LKC Reference: FRA251053 – Rutland Street Heywood

RE: LAND TO THE WEST OF RUTLAND STREET RUTLAND STREET, HEYWOOD – FLOOD RISK ASSESSMENT ADDENDUM

DRAINAGE CONSULTATION ON APPLICATION – 24/01076/OUT - LAND TO THE WEST OF RUTLAND STREET AND SOUTH OF STARKEY STREET, HEYWOOD OL10 4JJ

Figure 1 – Site Walkover Observations & Hand Pitting Locations

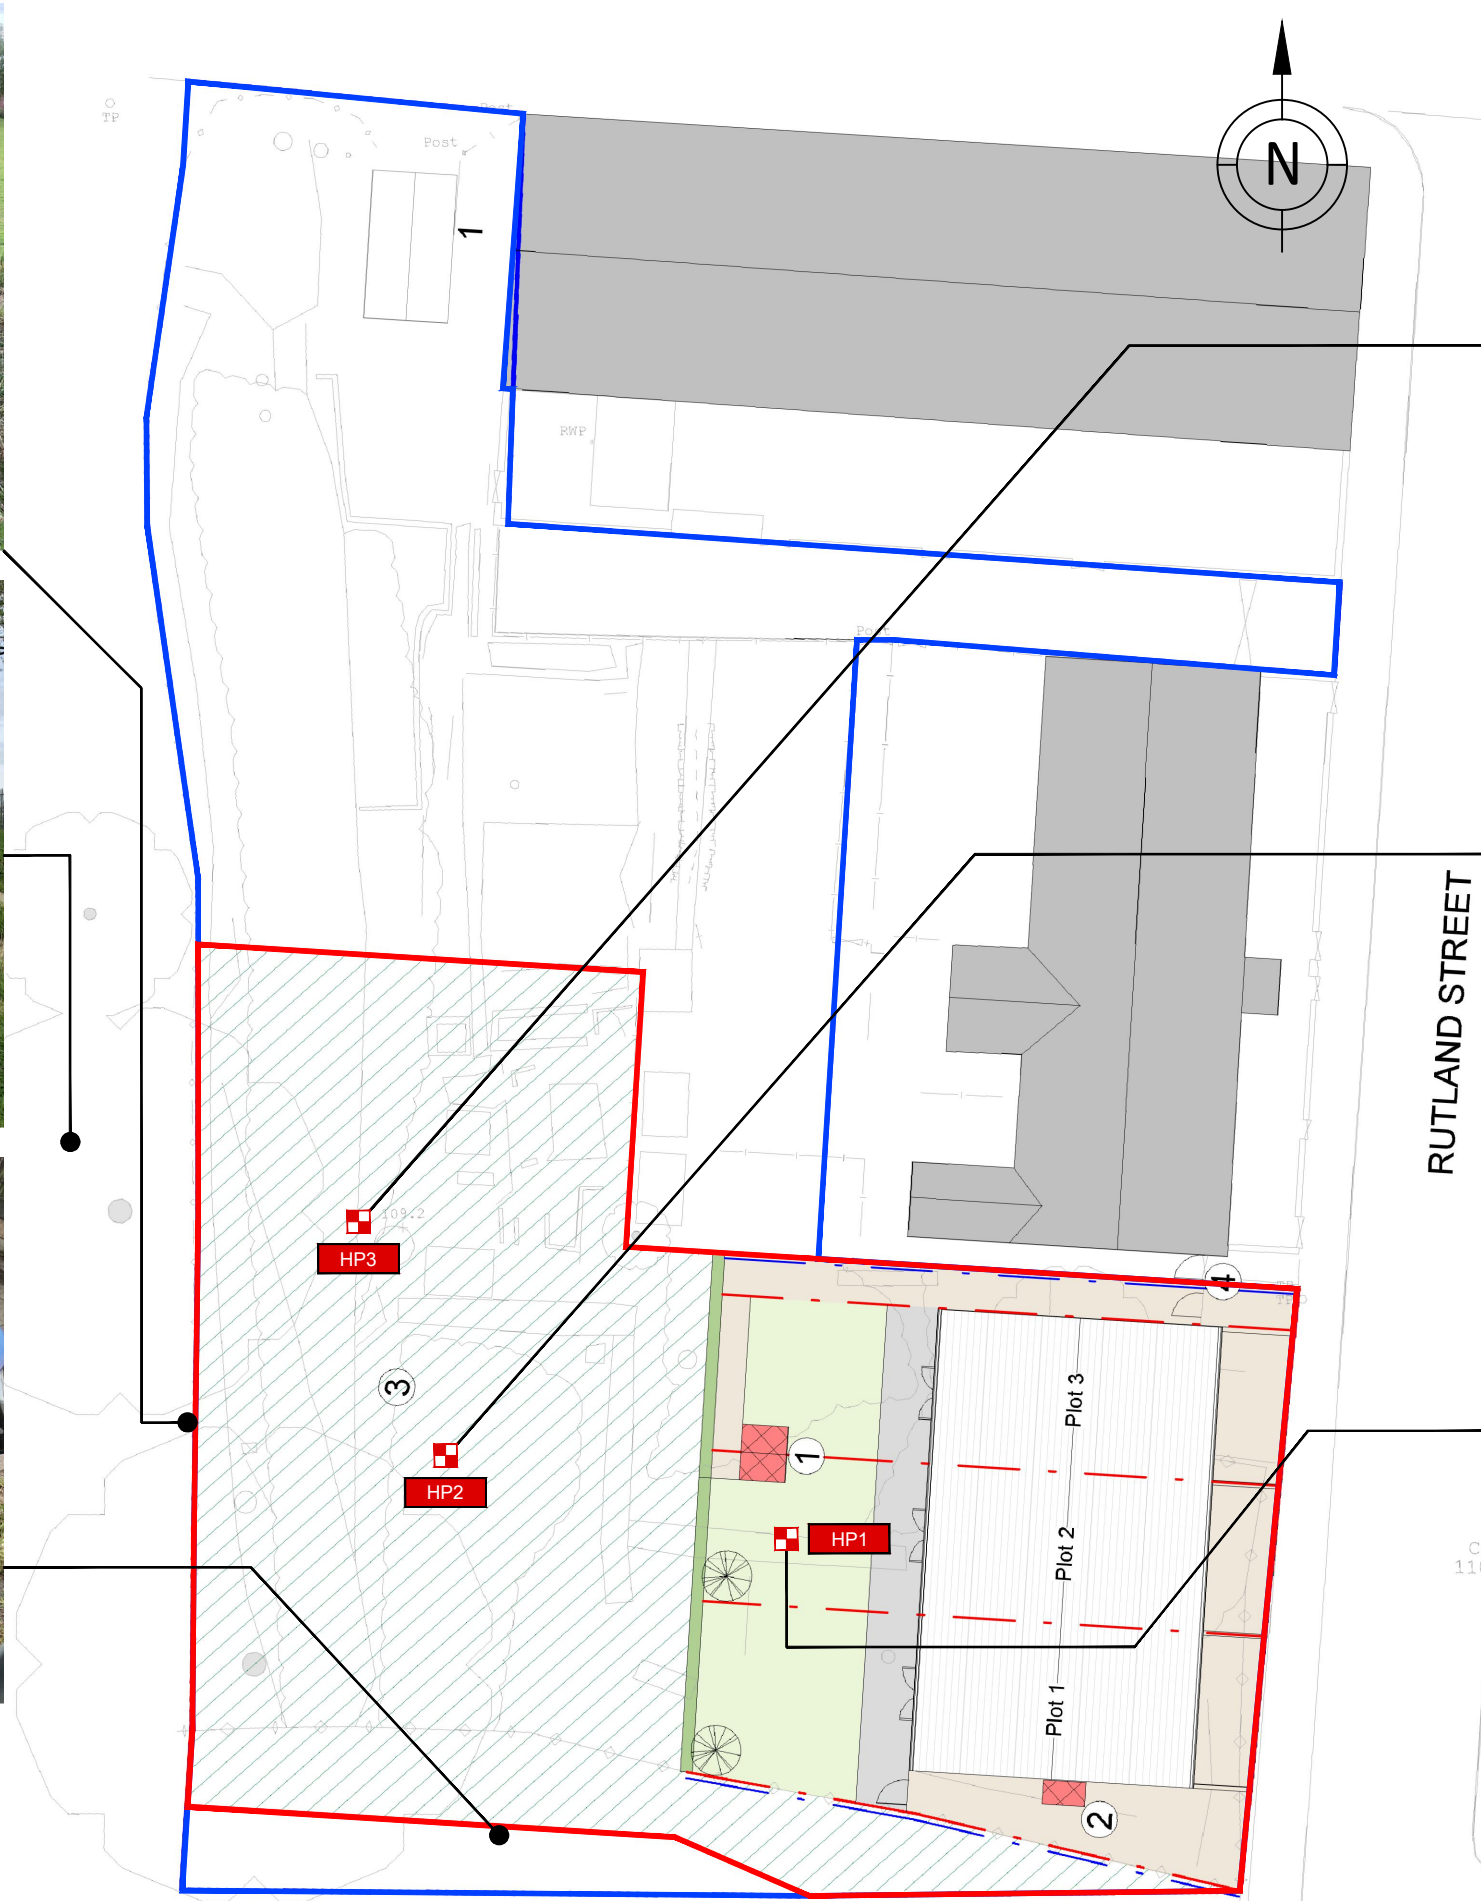
4. However, the BH logs indicate water at significant depths and a one suggests a reasonable degree of granular material. Therefore, the conclusions that infiltration is not feasible is not supported and should be investigated further with site-based data.

As part of the site walkover on 14th April 2025, hand pits were excavated to determine the underlying ground conditions. The hand pits confirmed the presence of generally clayey or silty clay strata beneath the site. On occasion, the material was slightly sandy and / or slightly gravelly. The locations of hand dug excavations are shown on Figure 1 and a summary of the arisings is provided in Table 3-1 below.

In addition, observations of the overall site setting were made during the walkover. It was noted that the southern boundary of the site to the neighbouring commercial units included a significant drop off supported by a concrete retaining wall estimated to be 3-5m and which was significantly higher than an adjacent Transit pick-up truck (see Figure 1). In addition, the slope adjacent to the western boundary was observed to be approximately 2-3m in height. Based on these physical constraints, along with the ground conditions encountered during hand pitting, it is considered that infiltration is not a suitable means to dispose of surface water runoff from the site. The site being elevated above the adjacent ground alone is considered sufficient reason for not utilising infiltration as point discharge into the ground could result in groundwater emergence and/or failure of the slope to the west.

Figure 2 – Outline Surface Water Drainage Strategy

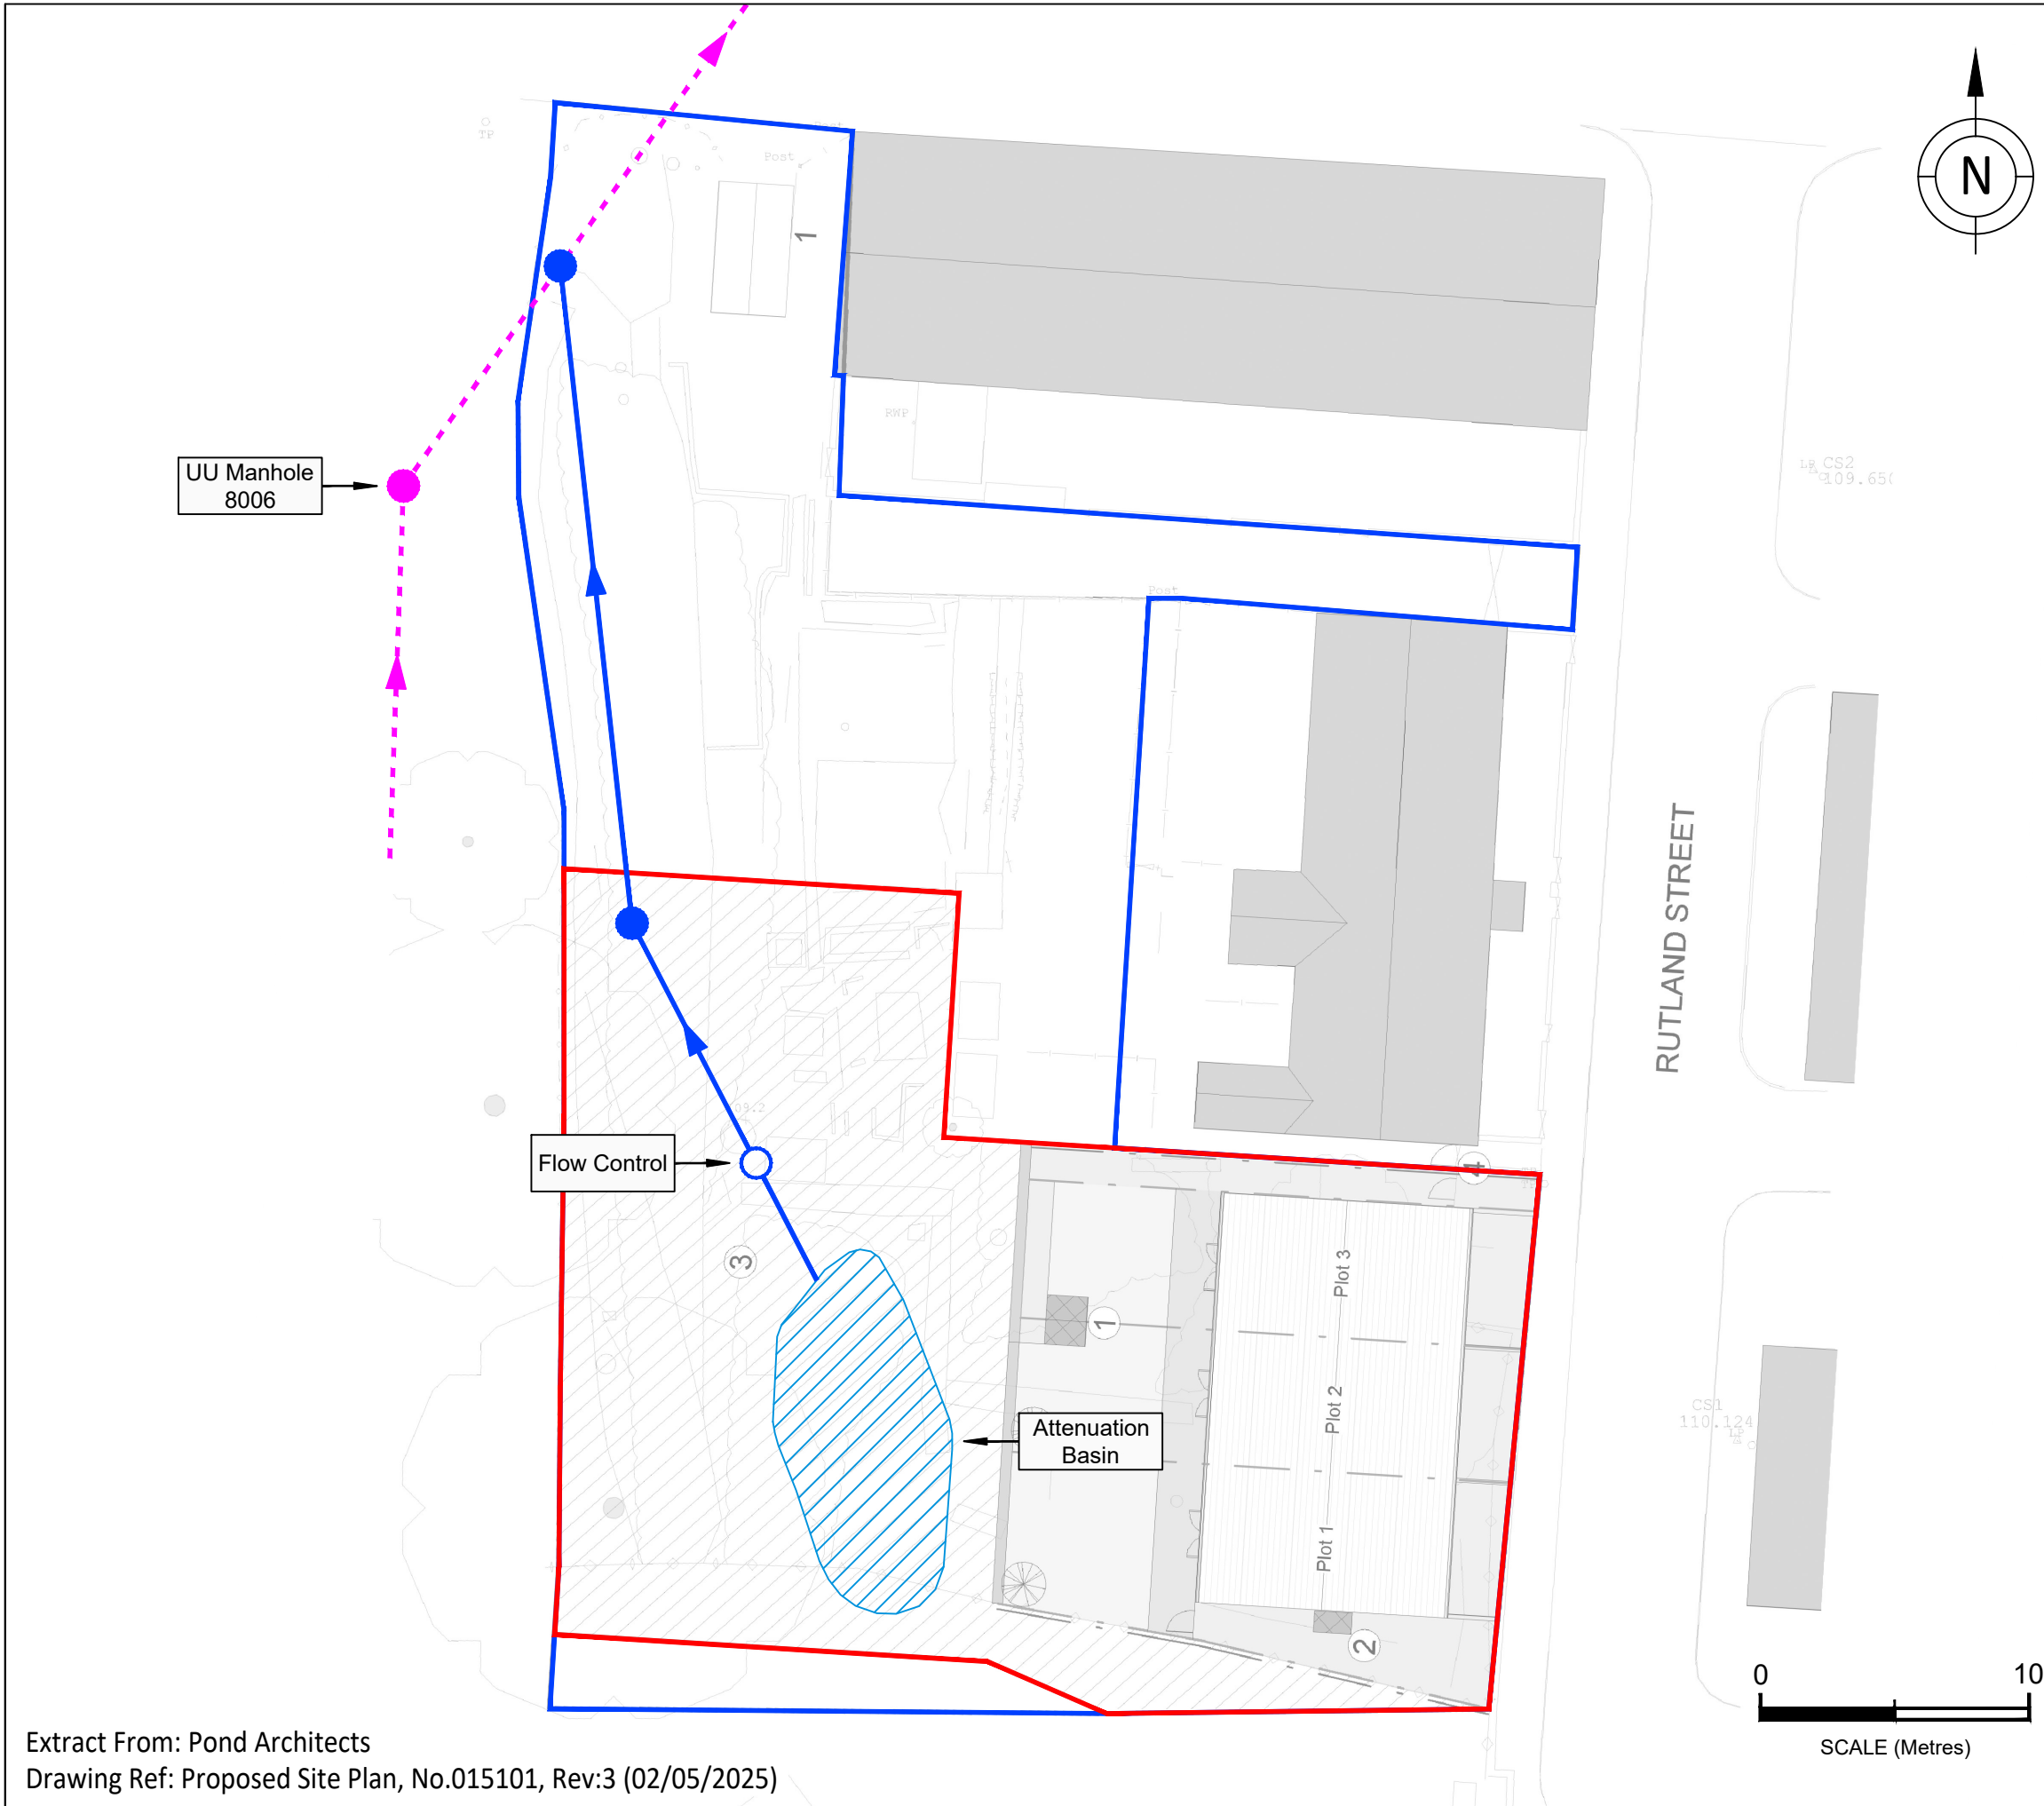
1. The FRA&DS does not show a proposed drainage layout for the development. The applicant has stated the site is located within a Critical Drainage Area. The applicant should upload a drainage layout drawing indicating the existing and proposed drainage regimes.

5. The FRA&DS has not adequately assessed green surface-based SuDS source control components. Most have been summarily discounted based on spatial constraints. However, it is considered that raingardens, tree-pits etc could be incorporated. No drainage layout has been submitted, and the report should be updated to incorporate a layout which considers all SuDS / drainage aspects.

It is proposed to provide surface water attenuation with an attenuation basin located to the rear of the proposed dwellings. The attenuation basin will measure a total surface area of 65.8m² with a depth of 1.3m (including 0.3m freeboard) with banks at a gradient of 1 in 3 and will provide 23.6m³ of attenuation. The basin will comprise a grassed depression in the landscape that will occasionally fill with water at times of heavy rainfall but will otherwise remain dry. The provision of an attenuation basin will provide treatment and amenity benefits in addition to the storage of surface water runoff. The location of the proposed attenuation basin, indicated on the Outline Drainage Strategy included as Figure 2, will be confirmed at the detailed design stage taking into account the fixed site layout. Causeway Flow calculations for the proposed attenuation pond are included as Appendix B. In addition, the North West SuDS Proforma has been completed to summarise the proposed drainage strategy and is included as Appendix C. The SuDS proforma should be read in conjunction with this FRA Addendum.

Surface water runoff stored within the attenuation basin will discharge to the culverted watercourse at a rate of 2.5l/s via a Hydrobrake or similar flow control device subject to agreement with UU. A connection to the culverted watercourse will be provided through land within the Applicant's ownership. The location and levels of the culverted watercourse should be confirmed via an appropriate survey at the detailed design stage.

LLFA Summary Comment	LKC Response
The outline FRA&DS should be updated to incorporate an outline proposed drainage layout.	This FRA addendum presents an outline surface water drainage strategy which aims to demonstrate that a suitable surface water drainage strategy can be achieved. The drainage strategy proposes to restrict surface water runoff to a rate of 2.5l/s during all events up to and including the 1 in 100 year plus climate change. Attenuation will be provided in the form of an attenuation basin with runoff discharging to the culverted watercourse via a connection through land within the Applicant's ownership.
Further assessment of infiltration potential is required.	Hand pitting has been undertaken on site which encountered the presence of generally clayey or silty clay strata beneath the site with occasional slightly sandy and /or slightly gravelly material. The presence of cohesive material is likely to preclude the use of infiltration for the disposal of surface water runoff. The site being elevated above the adjacent ground alone is considered sufficient reason for not utilising infiltration as point discharge into the ground could result in groundwater emergence and/or failure of the slope to the west.
